**WHITE LAKE TOWNSHIP  
INTER-OFFICE MEMORANDUM  
COMMUNITY DEVELOPMENT DEPARTMENT**

**SUBJECT: Cosmo's Car Wash  
Preliminary site plan approval**  
Property described as parcel number 12-20-276-034, located at the northwest corner of Highland Road (M-59) and Bogie Lake Road, consisting of approximately 1.88 acres, currently zoned (PB) Planned Business.

**RE: Cosmo's Car Wash- Preliminary Site Plan Review – 2<sup>nd</sup> Review**

**RE:** Cosmo's Car Wash  
Preliminary Site Plan – Review #2

ORIGINAL ISSUE:  
 8/30/2022  
 KHA PROJECT NO.  
 190125008  
 SHEET NUMBER  
**C3.0**

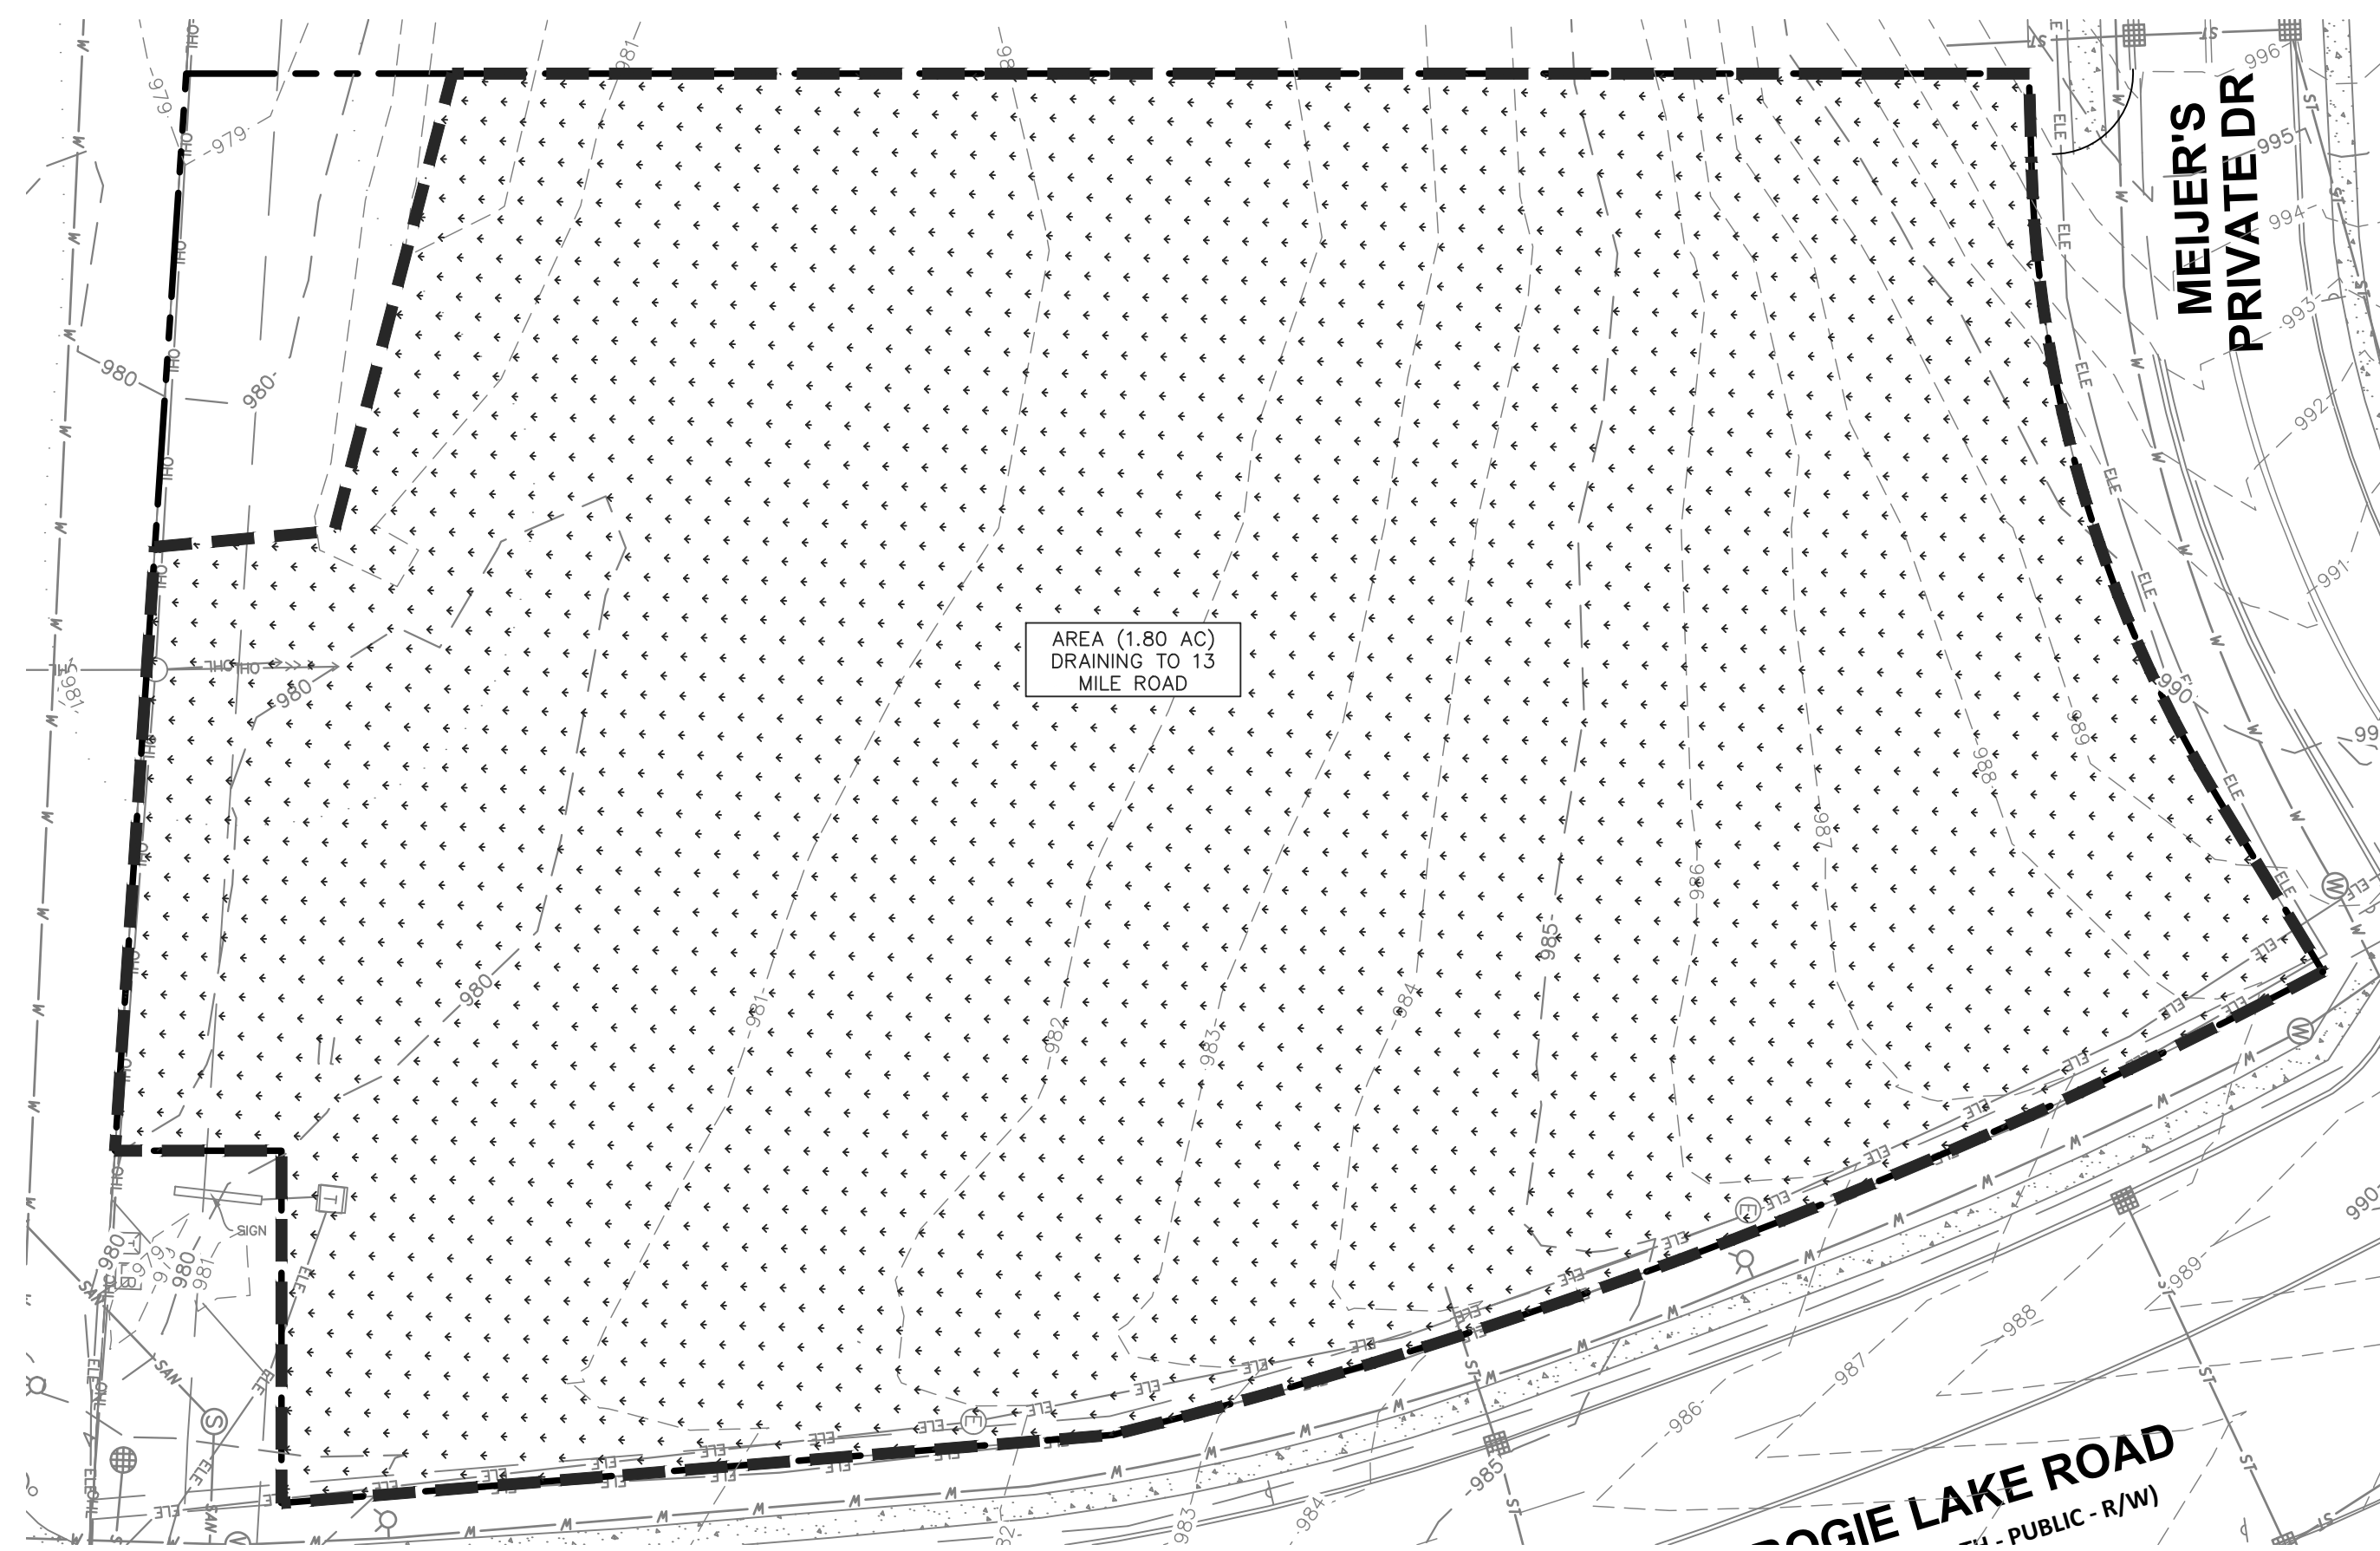
- m) *The proposed sanitary sewer pipe diameter shall be required to be 8" diameter (8" required if pipe length > 150'). **Comment partially addressed. An 8" diameter pipe is now indicated; however, remove reference to 6" diameter pipe from S1 to Ex. MH on Sheet C3. 0.***

Note 1 on C3.0 indicated  $\geq 3$ " CL 52 DI pipe. Township standard is CL54 DI Pipe though I did not see any new water main proposed on this plan. The service is shown as 2" and may be K type copper or DR-9 (200 PSI) Poly meeting ASTM D2737-03 specification.

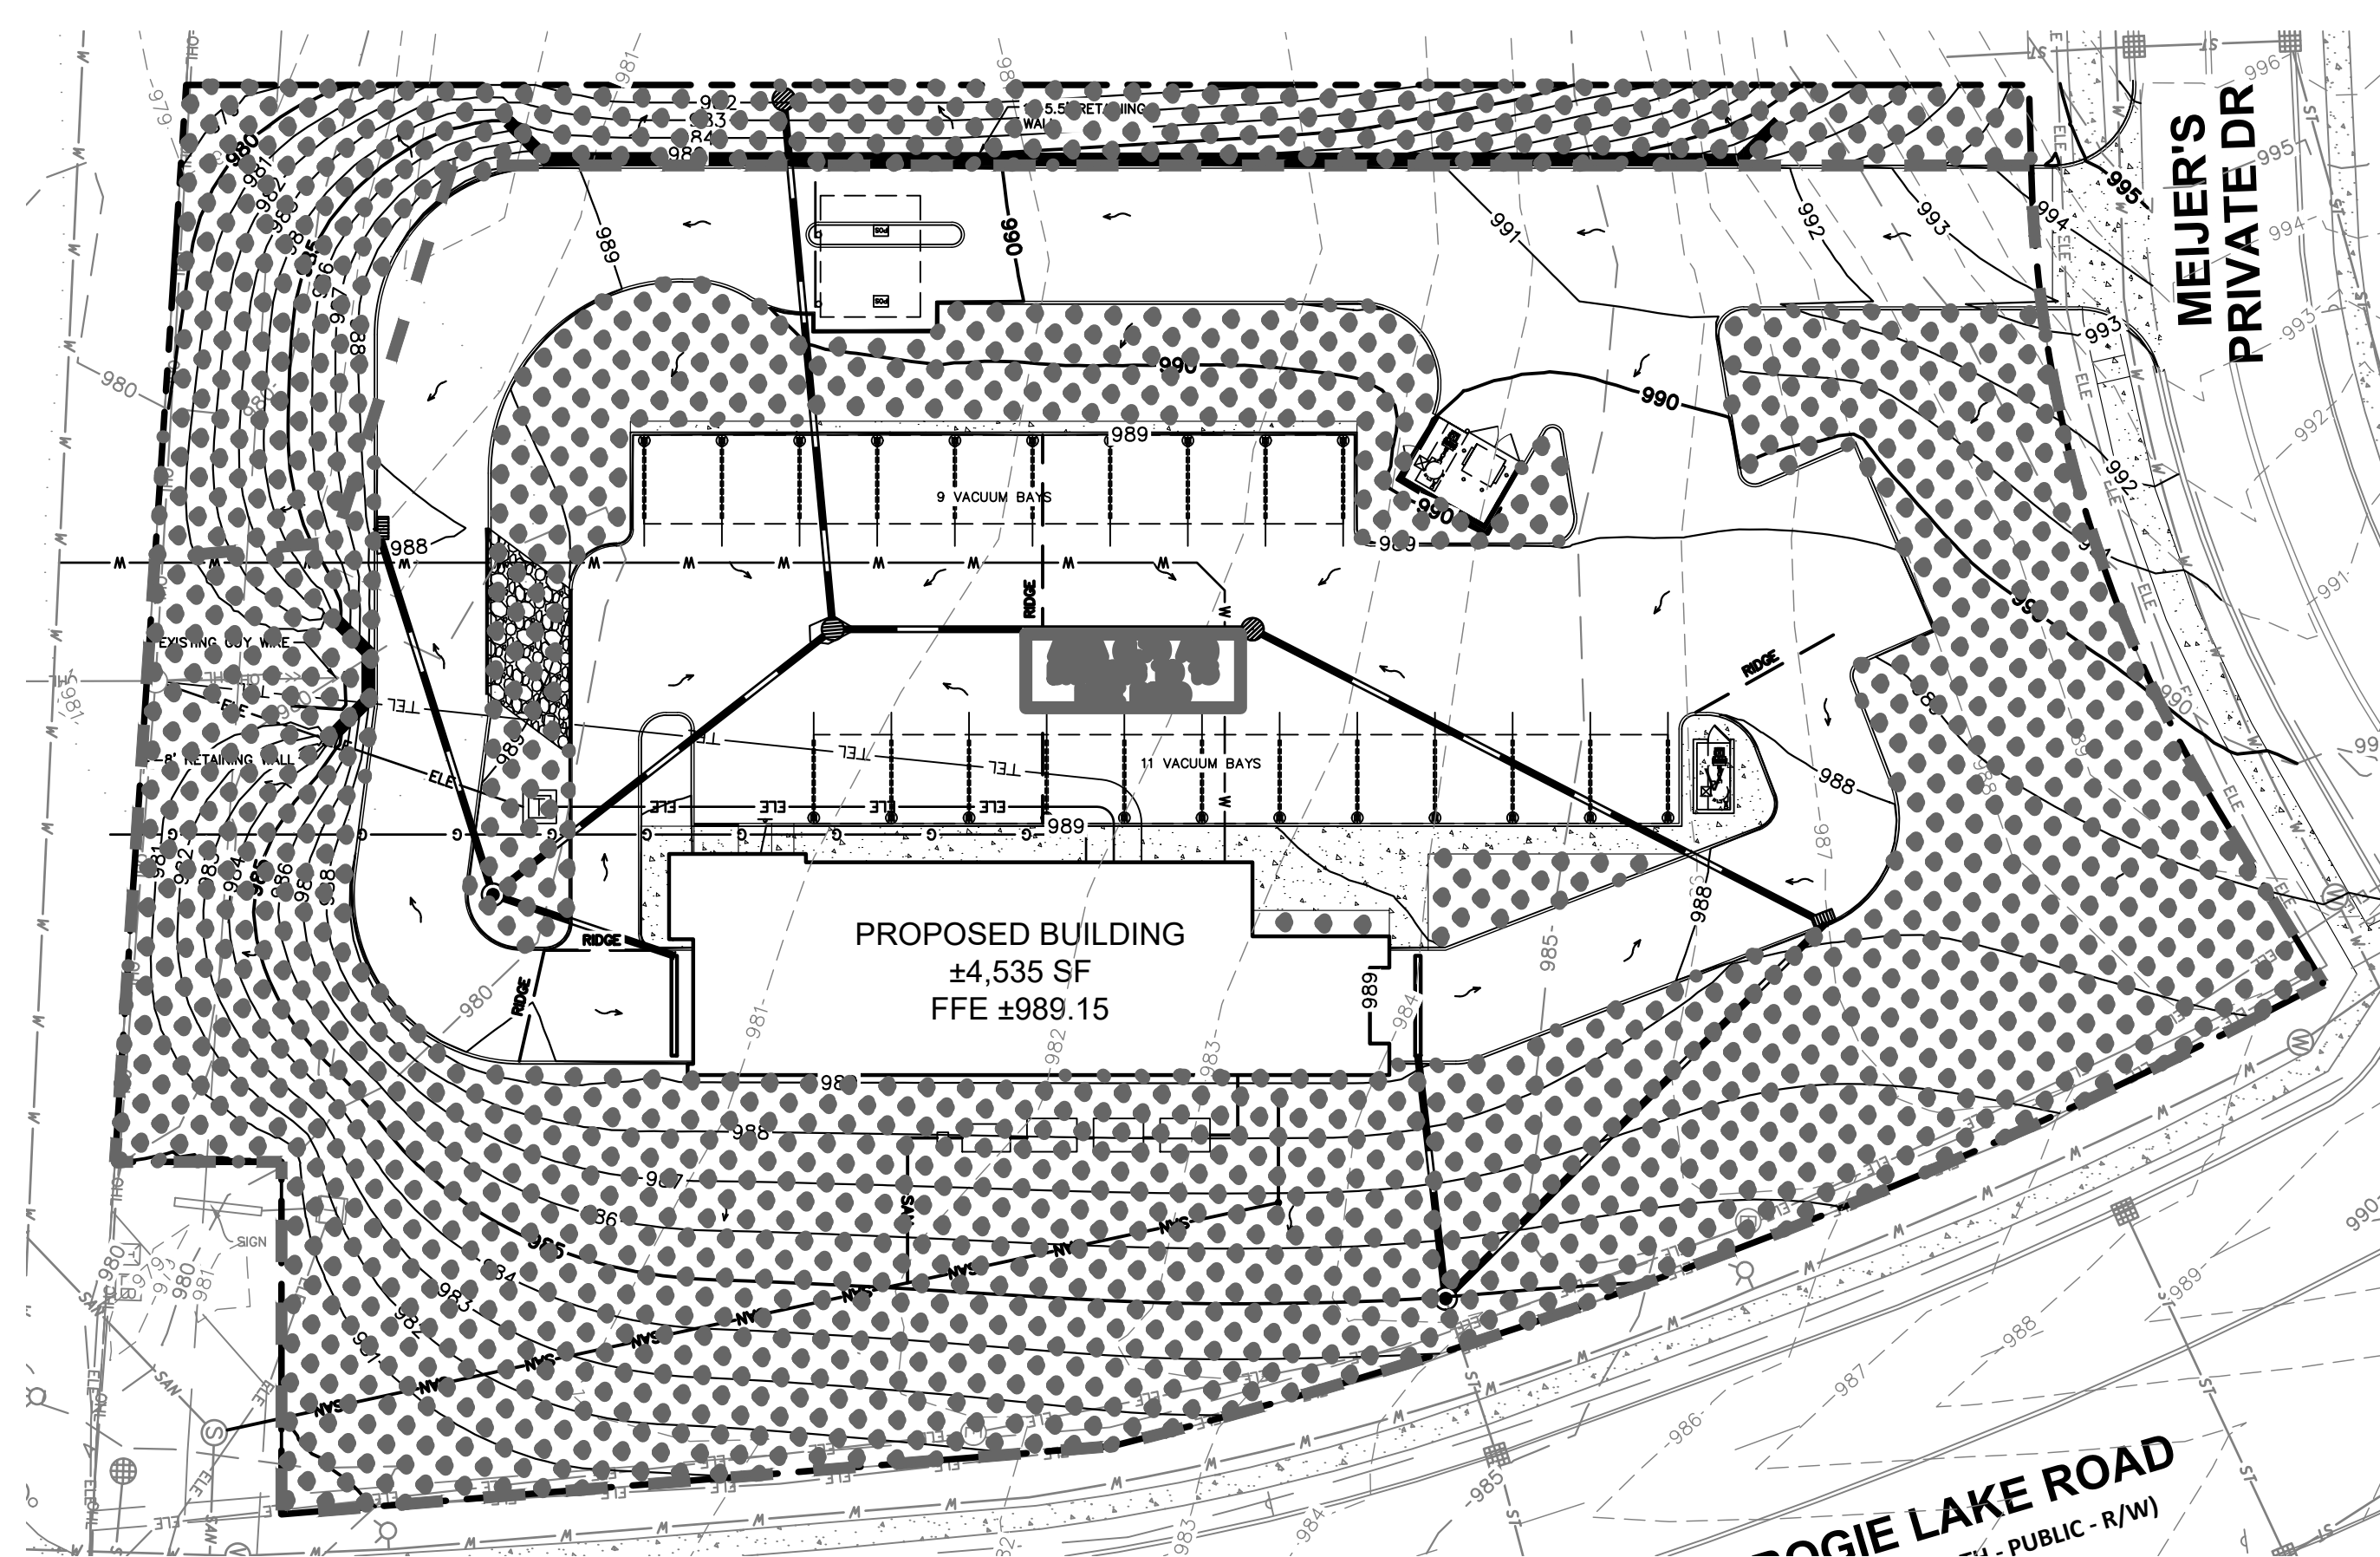
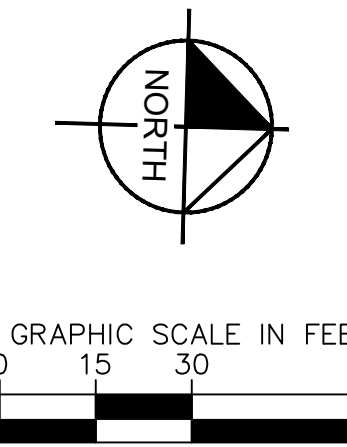
- k) *Show pre versus post development storm drainage that is being routed to the existing storm sewer structure near the corner of Highland Road and Bogie Lake Road. **Comment outstanding. Provide estimated pre- and post -development Q values. In addition, remove all references on this sheet (C4.0) to 13 Mile Road.***

L2.0

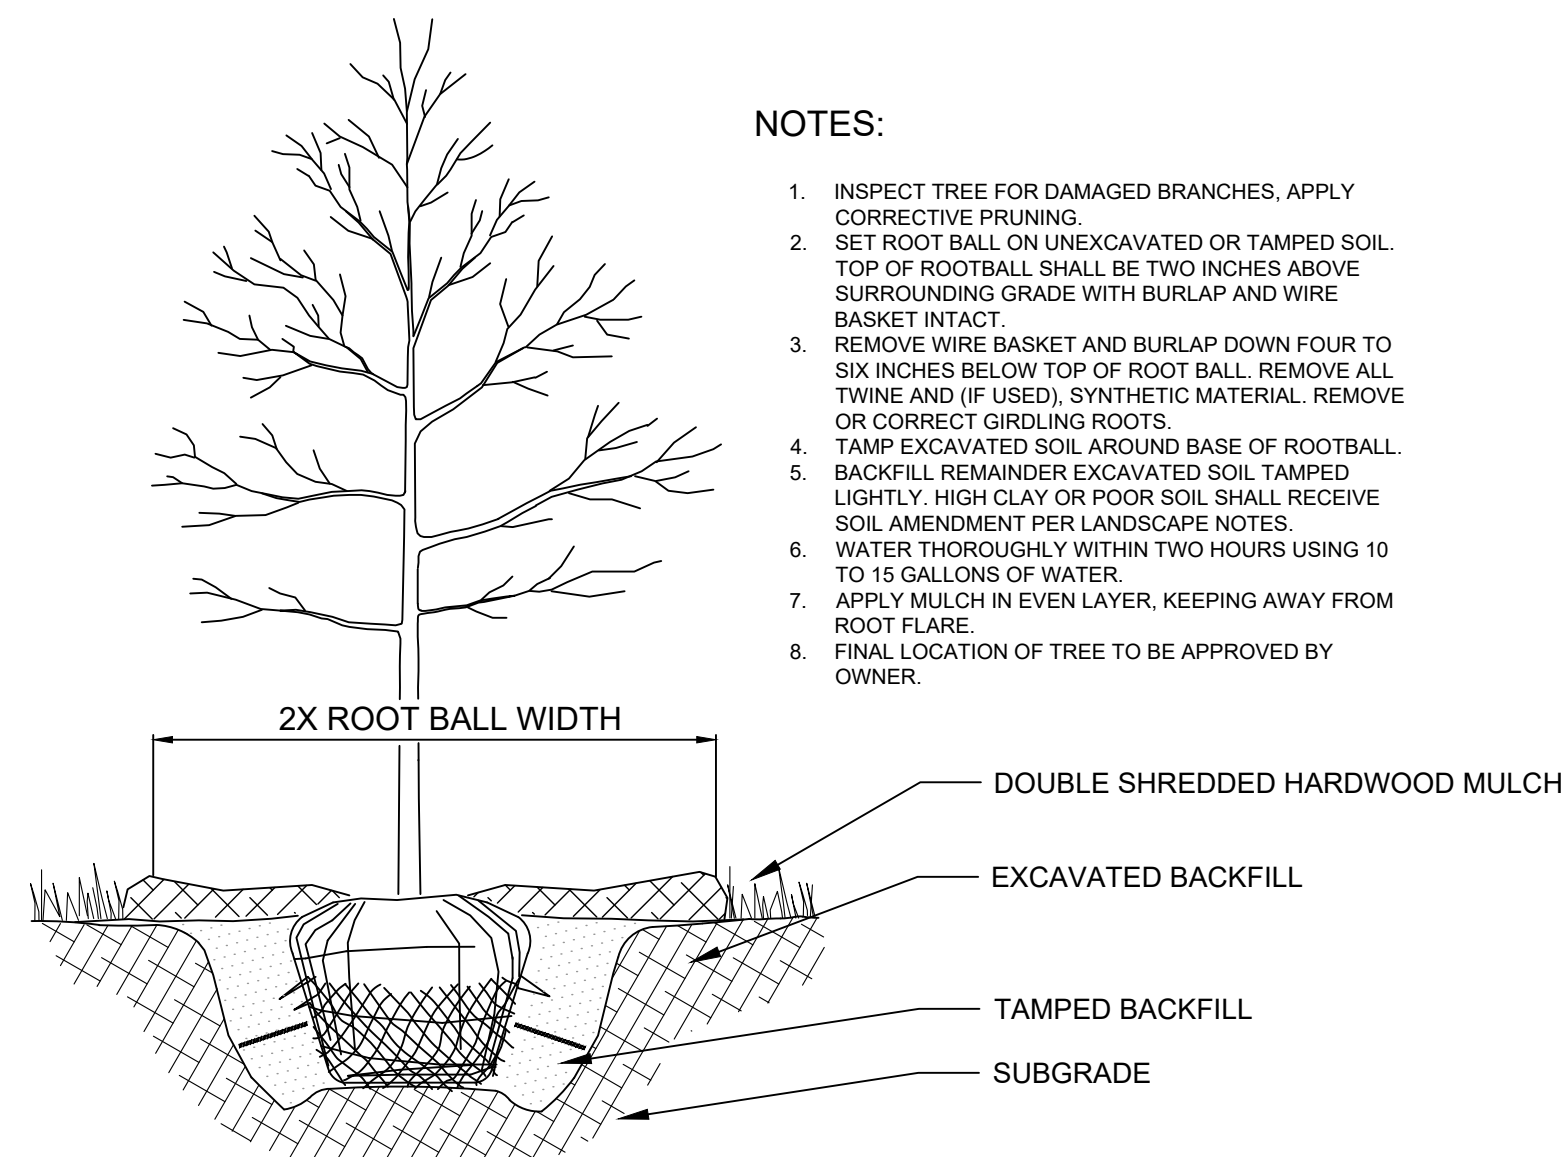
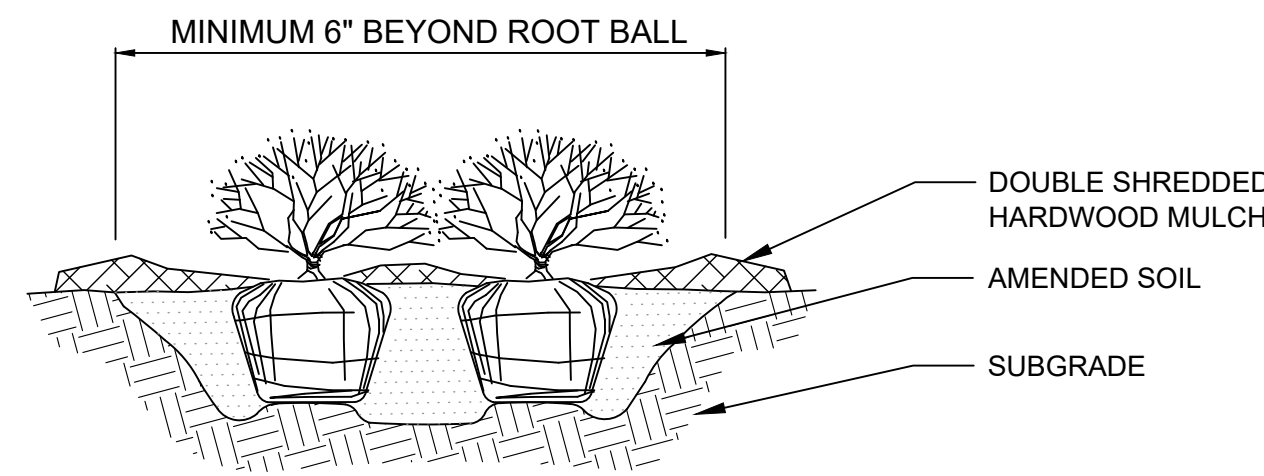
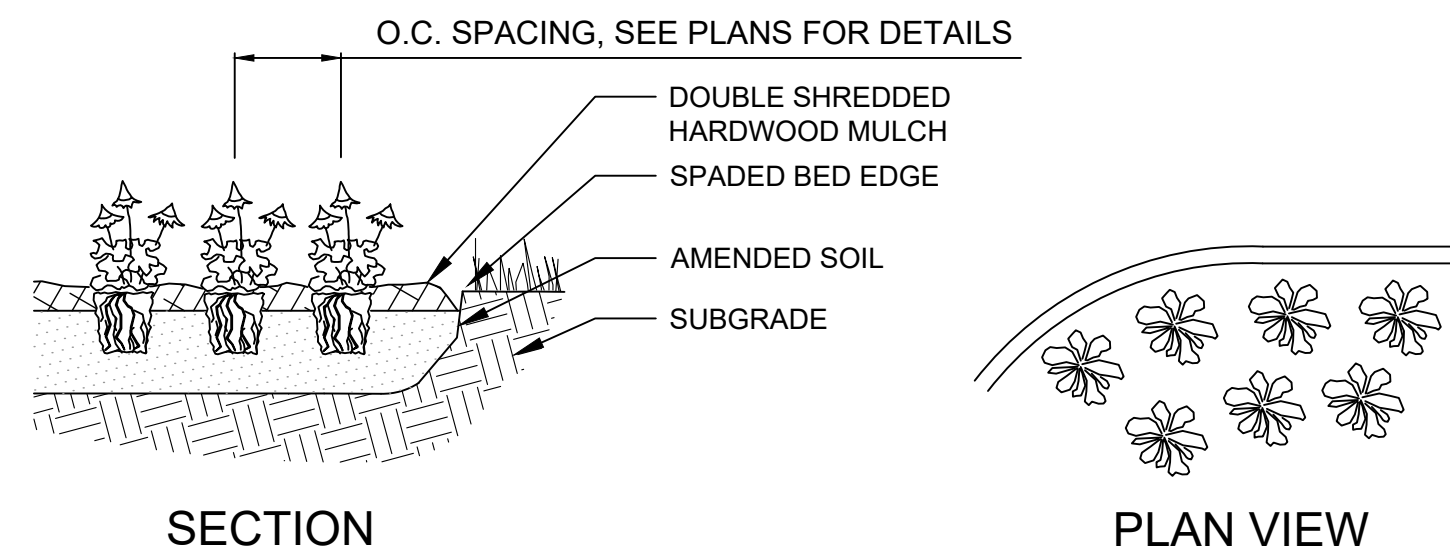
- **Notes 12 and 17 on Sheet L2.0 mention seed; sod is required. The aforementioned notes shall be revised and the ground cover name “turf seed” shall be replaced with “sod.”** (Comment addressed. Turf sod is now being proposed).

- **Note 14 and the Tree, Shrub, and Perennial planting details on Sheet L2.0 mention mulch. The zoning ordinance states the mulch product itself shall be at least double-shredded quality.** (Comment addressed. Double shredded hardwood mulch is now indicated).
